ECE/TRANS/WP.29/2007/107
4 October 2007

Proposal for Corrigendum 1 to the 01 series of amendments to Regulation No. 64
(Temporary use spare wheels/tyres)

Submitted by the Working Party on Brakes and Running Gear */

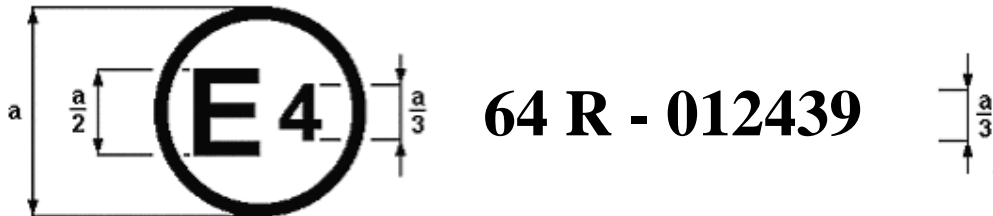
Paragraph 4.2., correct to read:

"4.2. An approval number shall be assigned to each type approval. Its first two digits (at present **01 corresponding to the 01 series of amendments**) shall indicate the series

Model A

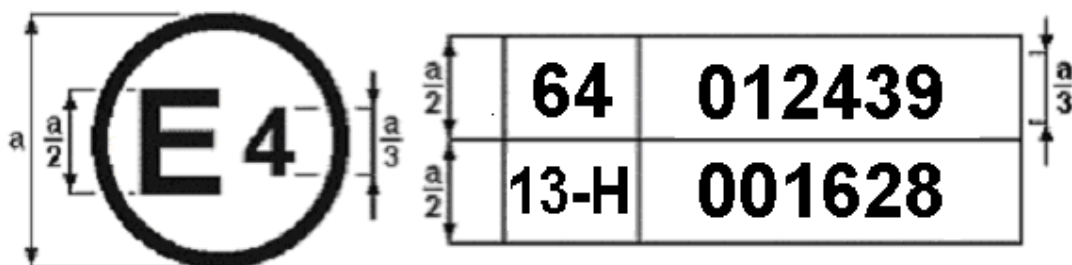
Annex 2, correct to read:

The above approval mark affixed to a vehicle shows that the vehicle type concerned has, with regard to the equipment of temporary-use spare unit(s), been approved in the Netherlands (E 4), pursuant to Regulation No. 64 under approval number **012439**. The approval number indicates that the approval was granted in accordance with the requirements of Regulation No. 64, **incorporating the 01 series of amendments**.
